1 Purpose of Document

This document summarizes the changes between the previous SAP5 silicon revision C and the current silicon revision D. These include requested UART design changes. The purpose of the redesign was to correct reported timing errors by the UART in the following modes: Master, Monitor, and Repeater. A problem with slave communication in special network constellations was also fixed.

Figure 2.1 Comparison of Valid MAN-Code Signal to Faulty MAN-Code Signal

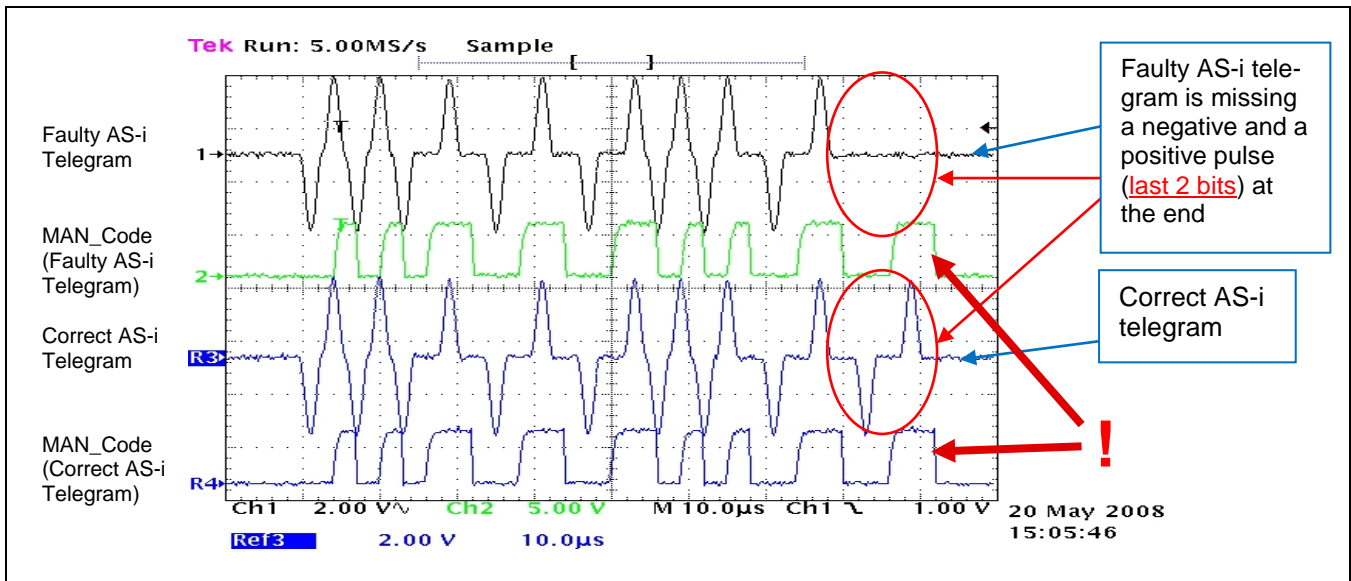
If the SAP5 revision C operates in Master Mode or in Repeater Mode, the error signaling for an *End_Bit_Error* does not work correctly. In some special cases, the generated MAN-Code of a signal with an *End_Bit_Error* looks similar to the MAN-Code of a signal without any errors as demonstrated in Figure 2.1.

This malfunction of the SAP5 revision C results in an MAN coded output signal that does not allow distinction between correct AS-I pulse sequences and pulse sequences that are shortened (missing one negative and one positive pulse). It occurs only under the following conditions:

- The parity of the signal is even.
- The last bit of the corrupt telegram is equal to binary 1.
- The *Stop_Bit* and the *Parity_Bit* or the *Start_Bit* and the *Control_Bit* are missing.
- If the *Start_Bit* and the *Control_Bit* are missing, the first pulse must have a negative polarity.

The following changes in the UART block were implemented in SAP5 silicon revision D:

1. A new principle for ASI-telegram pause detection was implemented. The previous method caused erroneous pause detection in some cases; e.g., a telegram starting with a wrong Start bit (SB=1) and second bit = 0.
2. A new *Endbit_error* detection principle was implemented to comply with the *AS-I Complete Specification V3.0*. The new principle ensures that an *Endbit_error* is detected only if the polarity of the pulse at time (36µs/78µs ± tolerance) is negative.
3. The internal computation of *No_info_error*, *Timing_error*, and *Length_error* was reviewed and corrected to comply with the *AS-I Complete Specification V3.0*.

Figure 3.1 Test for SAP5 Revision C Error in Master Pause Detection

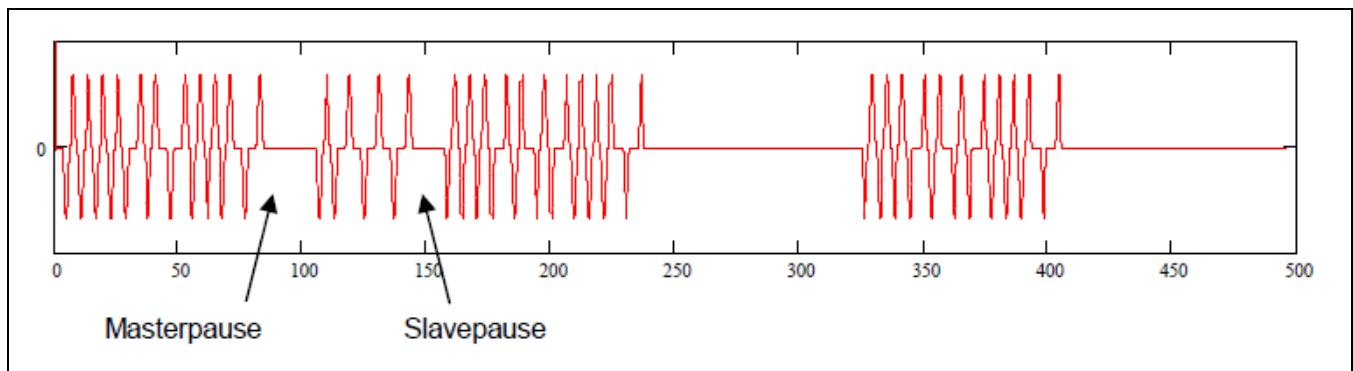
If the previous SAP5 revision C is operated in Slave Mode, the UART Master Pause detection does not always function correctly when the UART must listen to slave responses from a different slave. Depending on the actual AS-I line pulse timing, a slave response from a different slave is sometimes not recognized correctly, which results in a UART communication error. This prevents the Slave from understanding the next Master telegram correctly. If the Master telegram addresses the Slave itself, the error leads to a missing slave response and the Slave replies on a second repetition of the Master Call to its own address in asynchronous mode.

Figure 3.1 shows a telegram test case to reproduce the error. The AS-I signals shown in Figure 3.1 were generated by a signal generator that allowed sweeping the Master Pause and Slave Pause duration over the allowed specification limit. The first Master Call contains a different slave address than the tested slave. The second and third master calls address the tested slave. The tested slave replied with the erroneous behavior for certain Master pause and Slave pause scenarios only. The majority of the test cases were passed without error.

A new principle of AS-i telegram pause detection was implemented in SAP5 silicon revision D that is more precise and able to cover all valid timing scenarios for Master and Slave pauses. The new principle is now independent of the internal timing constraints of the UART state machine.
